**Subject: Transmittal of Class 1 Permit Modification to Remove Structures from the Los Alamos National Laboratory (LANL) Hazardous Waste Facility Permit, EPA ID #NM0890010515**

Enclosure: *Class 1 Permit Modification for Removal of Structures from Technical Area 63*

### **Removal of Structures from Technical Area 63**

FIGURE G.27-1.

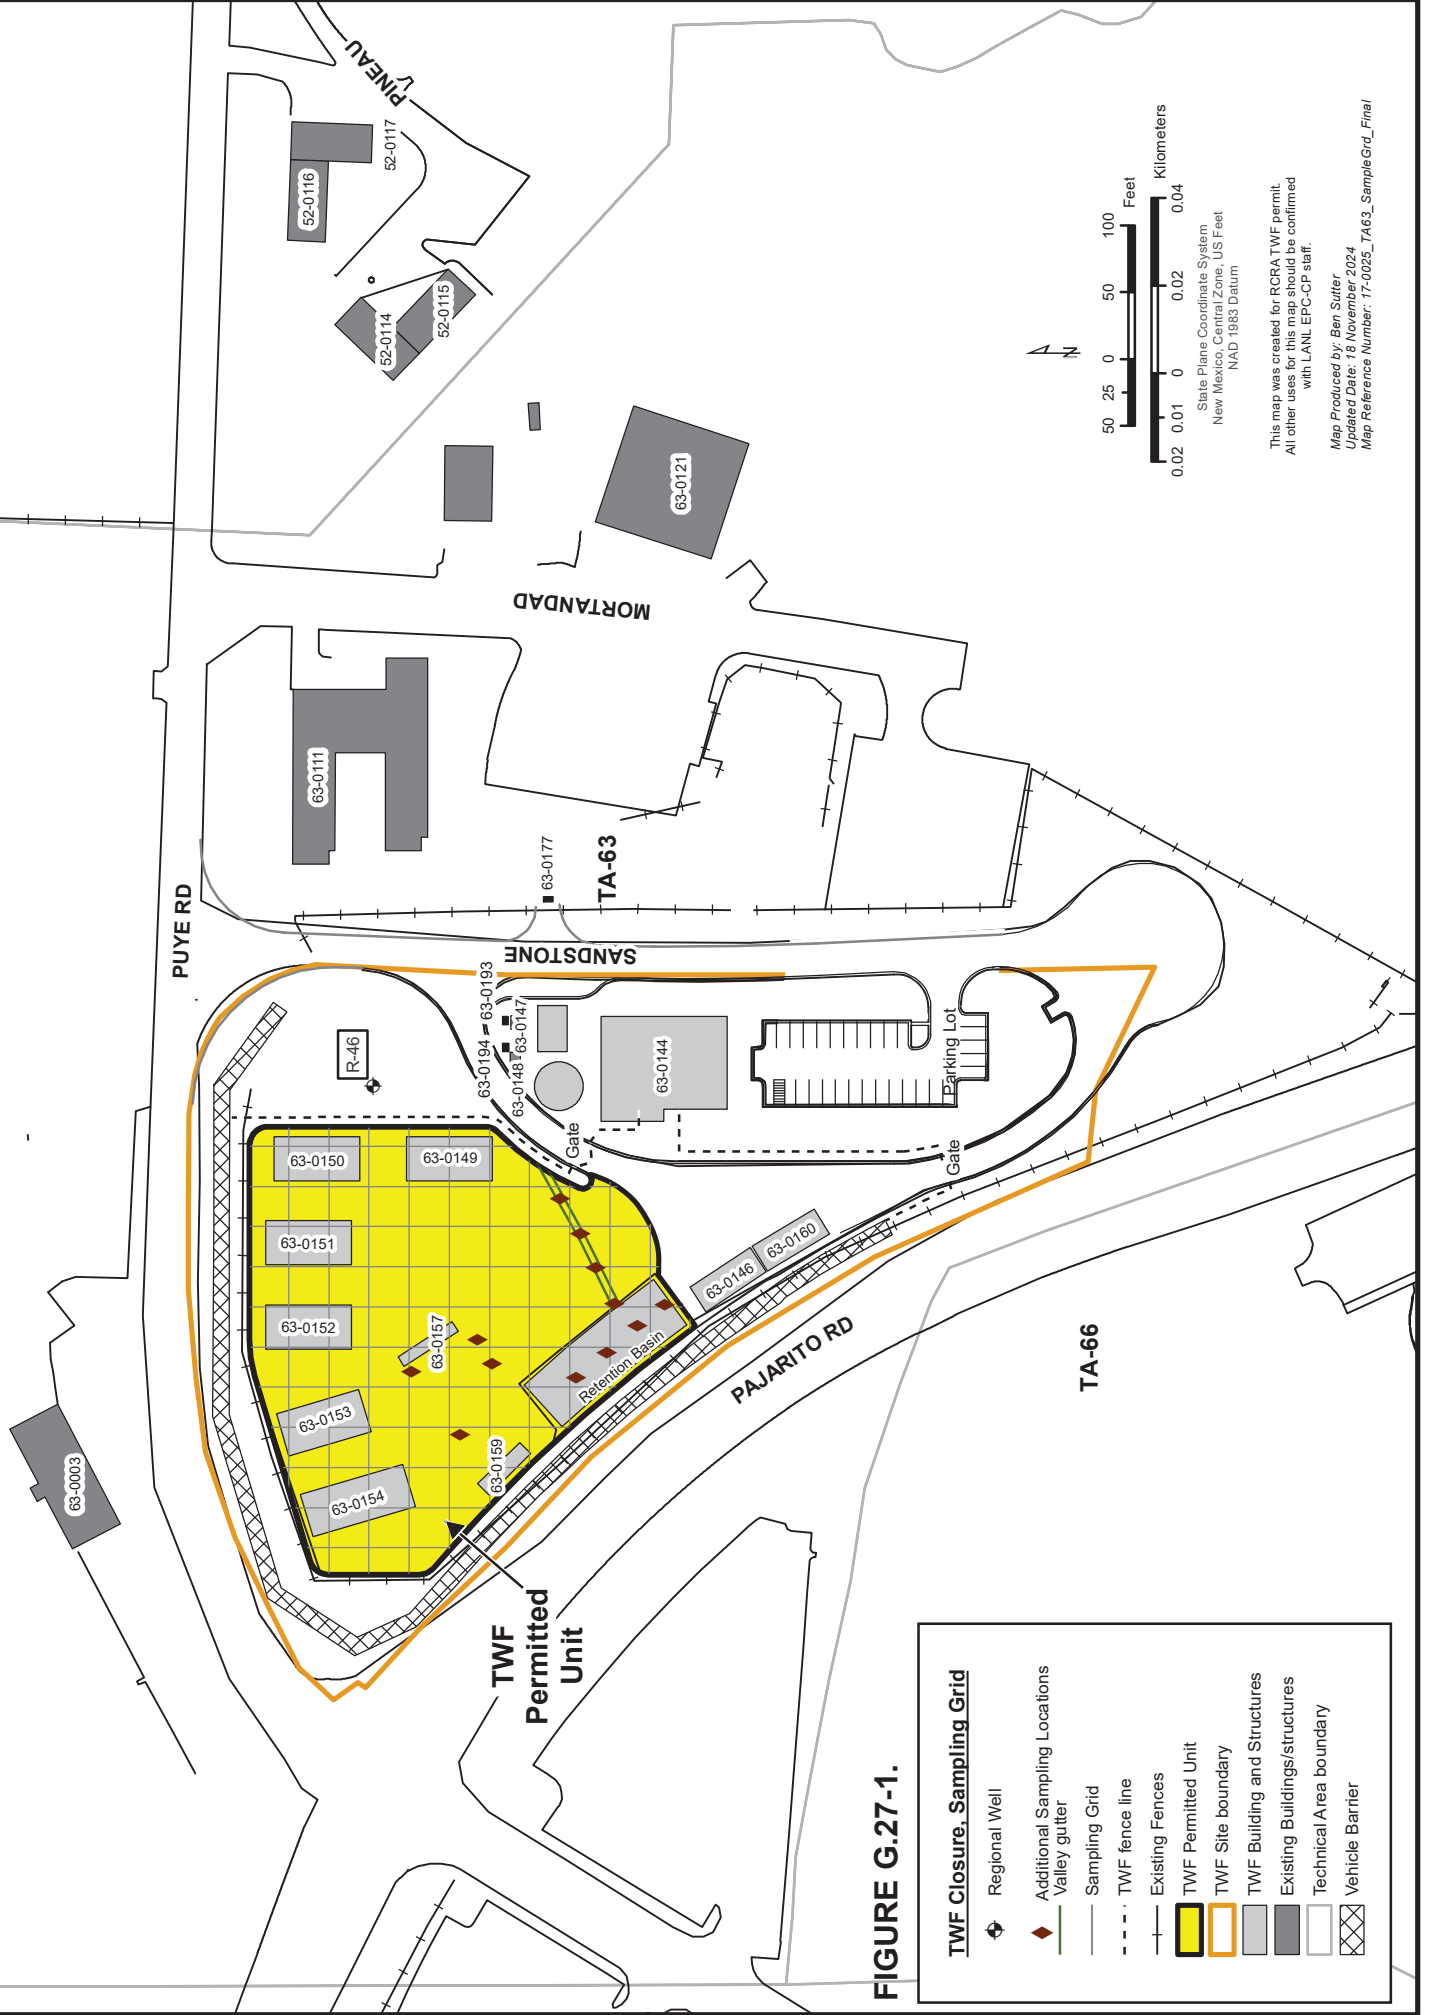
Attachment G.27, *Technical Area 63, Transuranic Waste Facility Closure Plan*, revision reflects the removal of structures TA-63-0155 and TA-63-0156 from the description of unit to be closed and an updated Figure G.27-1 is provided.

- Storage Buildings: 63-0149, 63-0150, 63-0151, 63-0152, and 63-0153
- Storage and Characterization Building: 63-0154
- Characterization Trailers: ~~63-0155, 63-0156, and 63-0157~~6
- Concrete Storage Pad

Figure 56

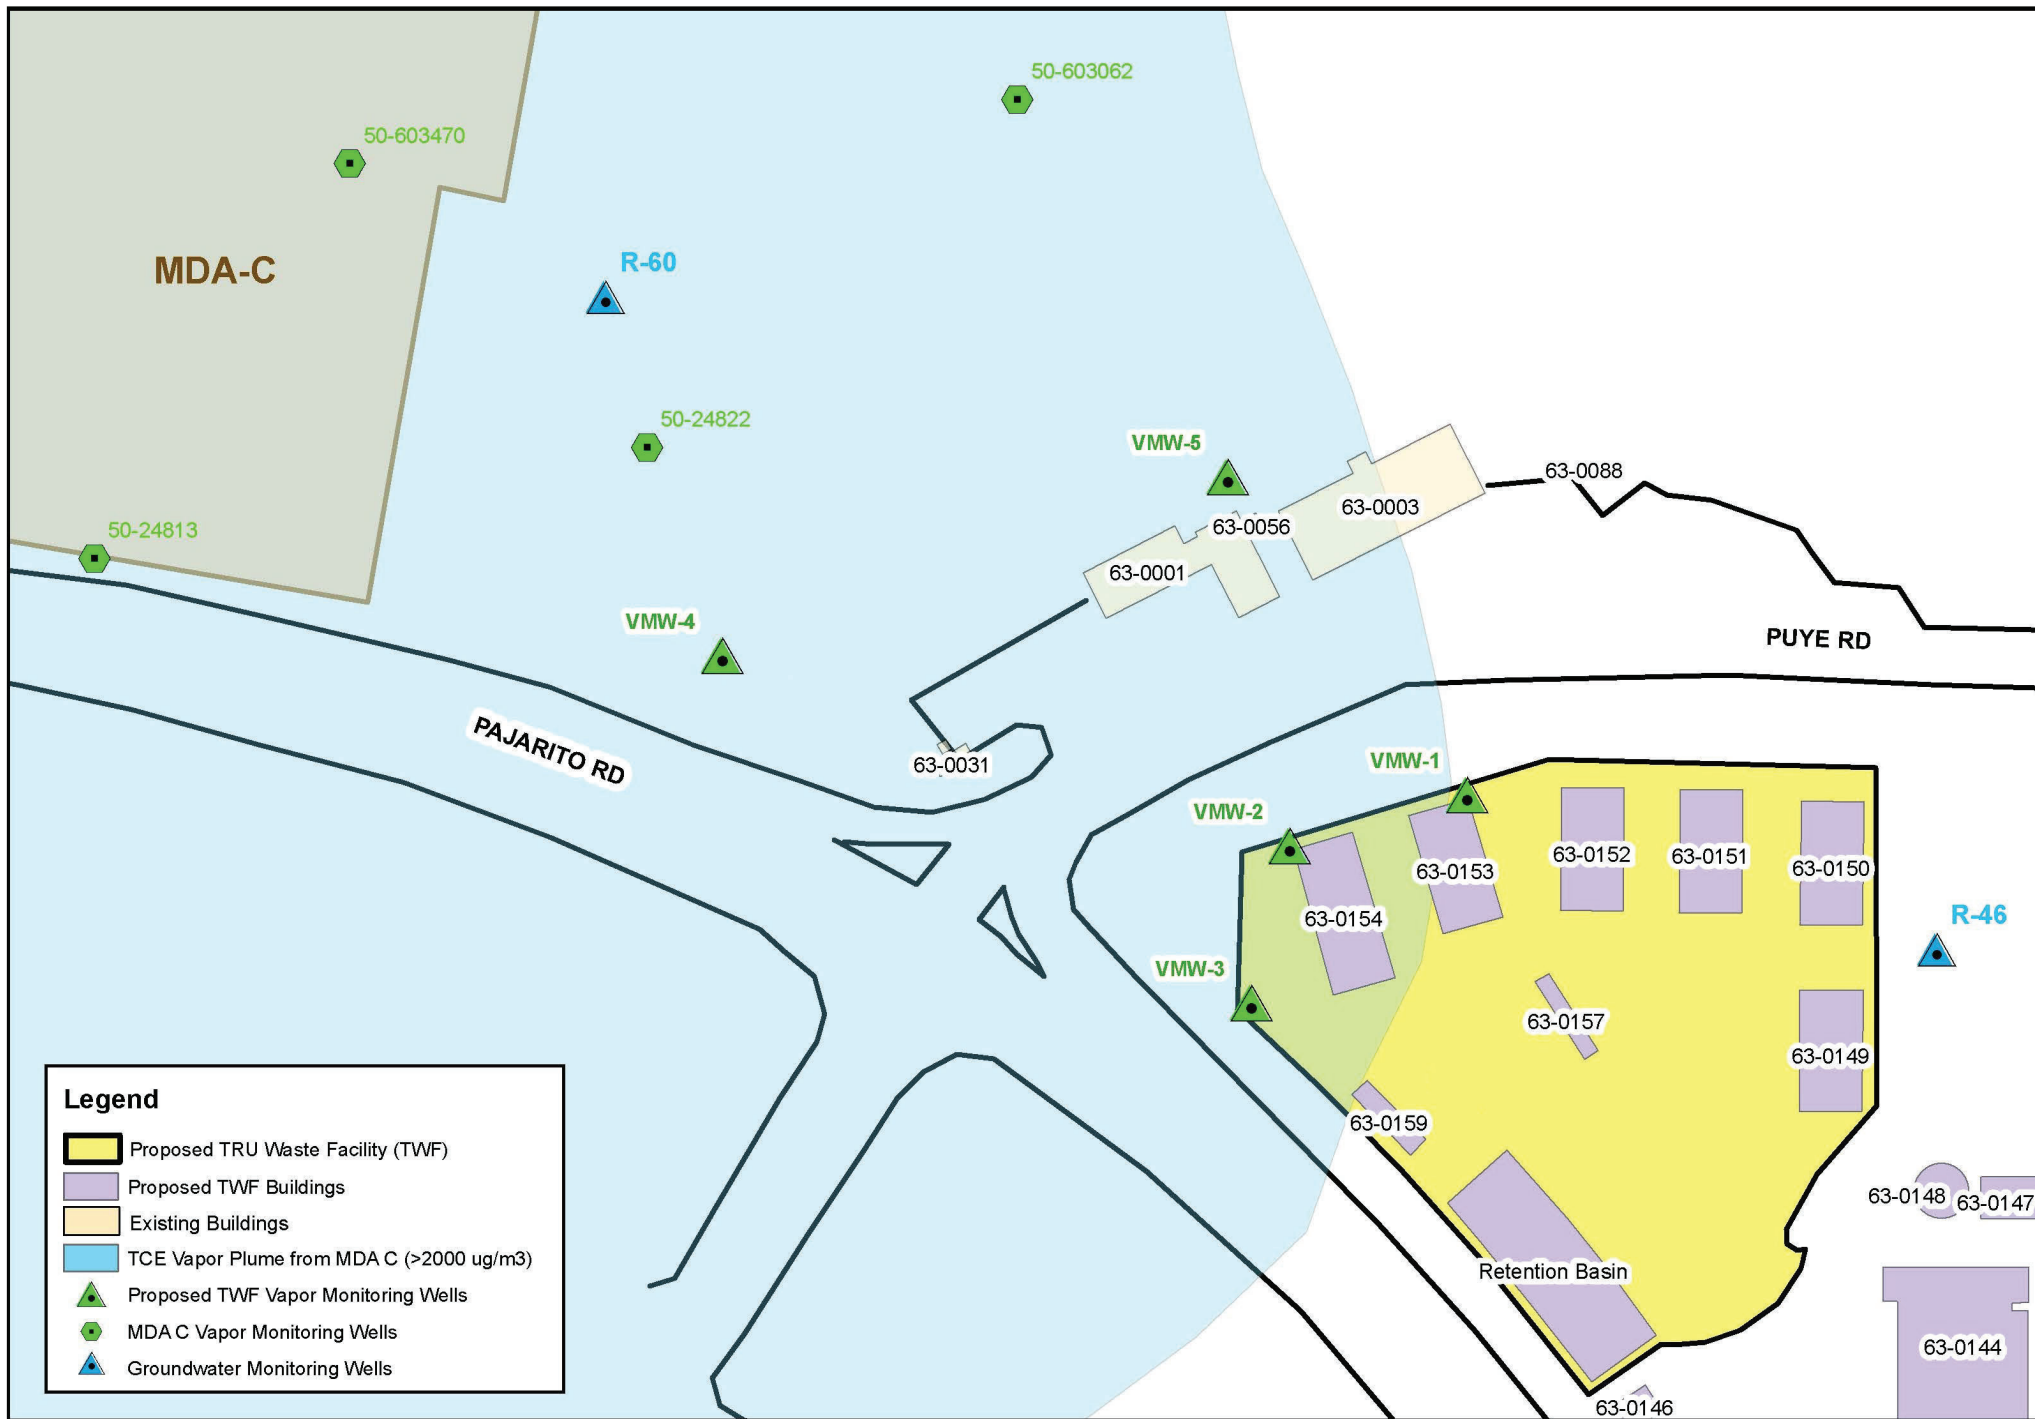
Attachment N, *Figures*, revision reflects the removal of structures TA-63-0155 and TA-63-0156 from Figure 55, *Technical Area (TA) 63 Transuranic Waste Facility*, and Figure 56, *Transuranic Waste Facility Subsurface Vapor Monitoring Network*.
